URBAN DESIGN COMMISSION APPLICATION

Butler Street Elevation
121 North Butler
October 8, 2018

Memo

Project: 121 North Butler

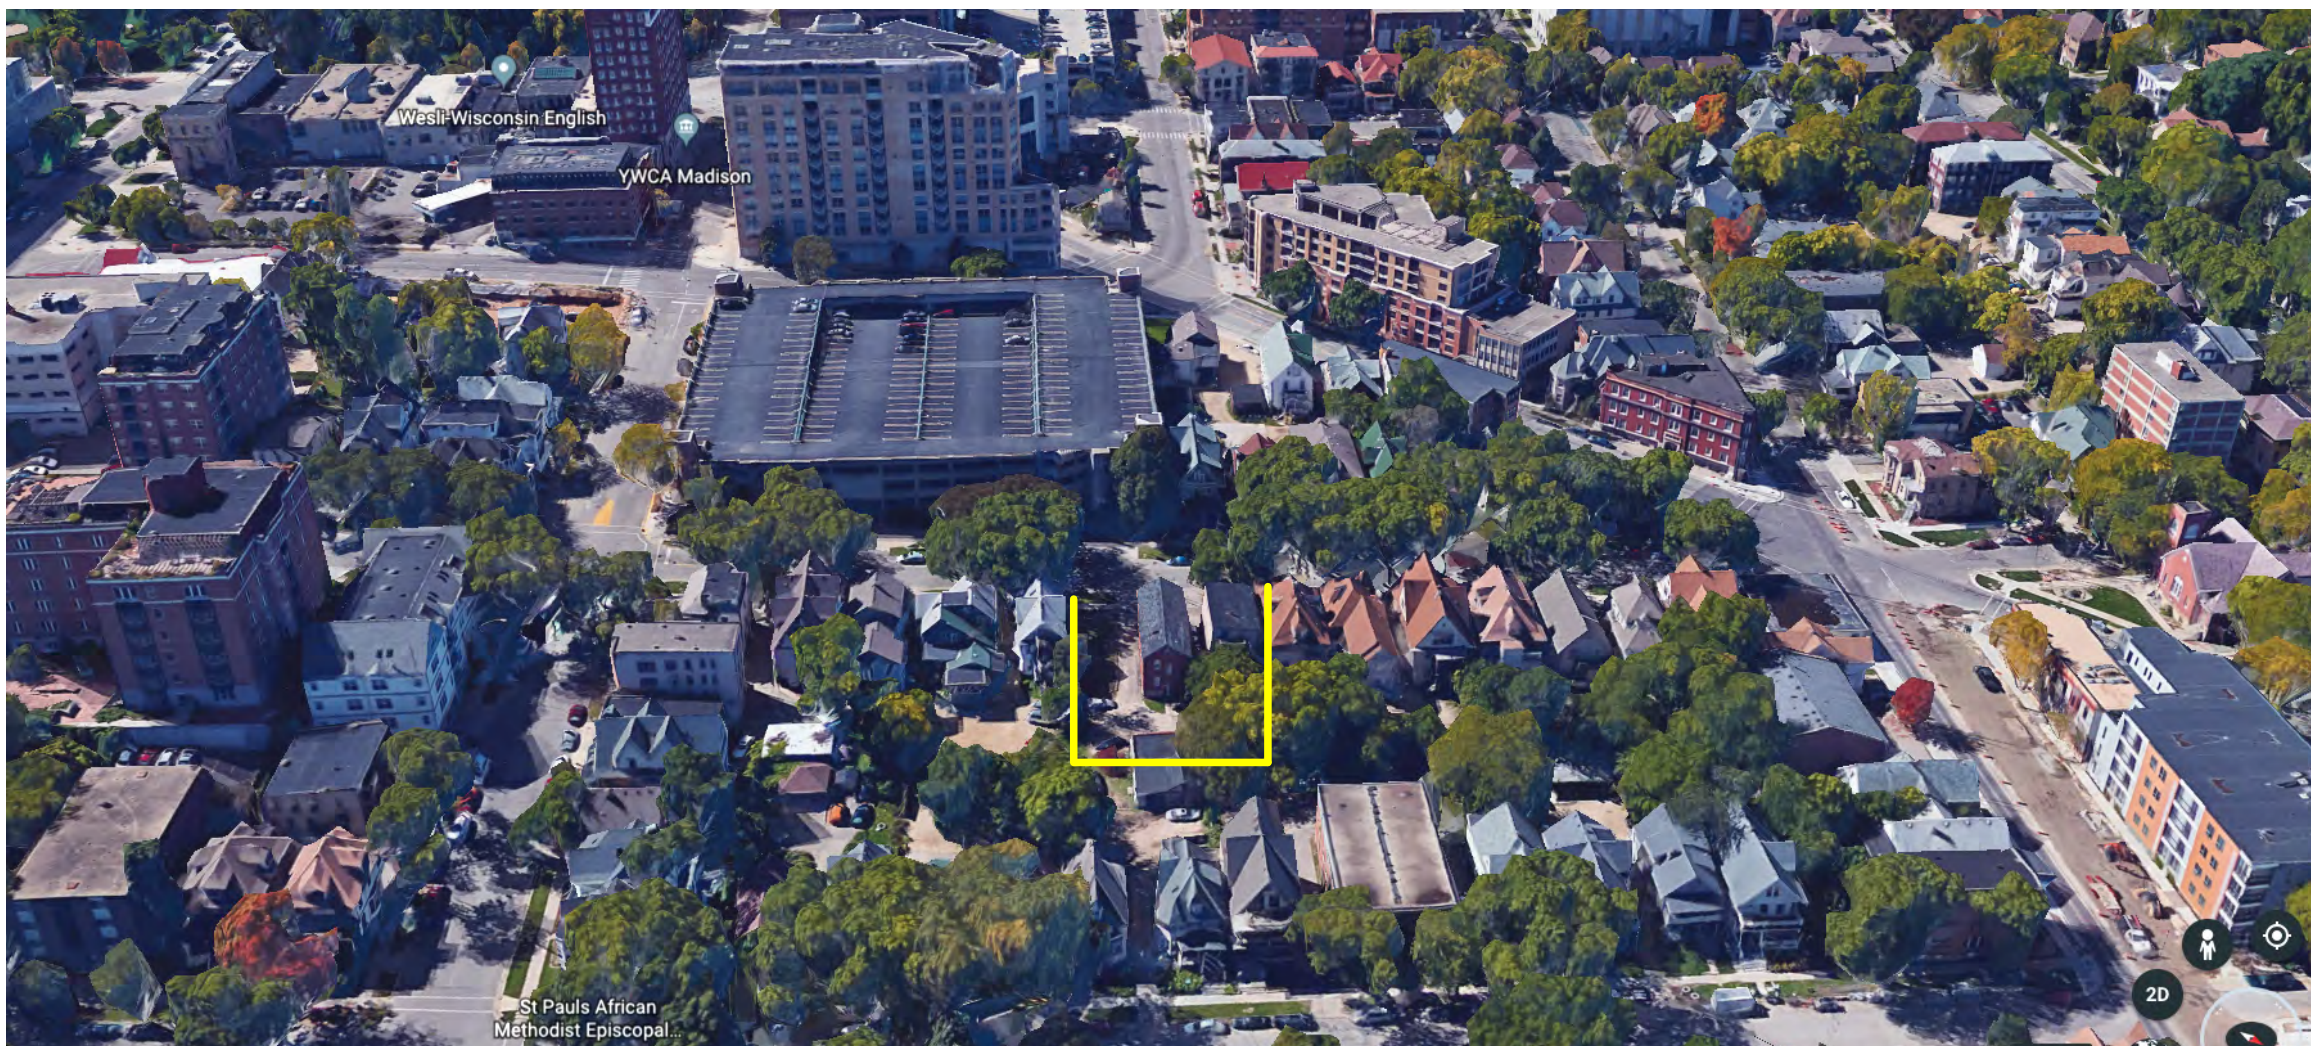
The Plan Commission in their review of the new four-story apartment building to be built at 121 North Butler voiced two related aesthetic concerns and asked that we seek the advice of the UDC on how best to resolve them.

In the words of the Plan Commission the building as originally proposed and as illustrated to the left seemed “to sink into the ground”. It was noted that older buildings similar in style to the one proposed here have traditionally had the first floor elevated comfortably above the sidewalk and featured raised porches complete with railings accessed via a front stoop with four or more steps.

Every vernacular has its particular grammar any violation of which is aesthetically jarring. In our attempt to provide an at grade entry at the front door we mistakenly set the ground floor elevation too low and sloped the front yard up towards the building further minimizing visually the actual of height of the ground floor above the sidewalk. Furthering the problems the front stoop was eliminated and low decks were substituted for a defined front porches.

A slight shift in approach starts to address the concerns raised. The building was raised a foot and a half but more importantly the natural grade along the front of the property has been retained following the slope of the sidewalk down from south to north along Butler Street. In combination this elevates the first floor both physically and visually more comfortably above the street. In addition a front stoop has been reintroduced and the building now features a pair of raised front porches.
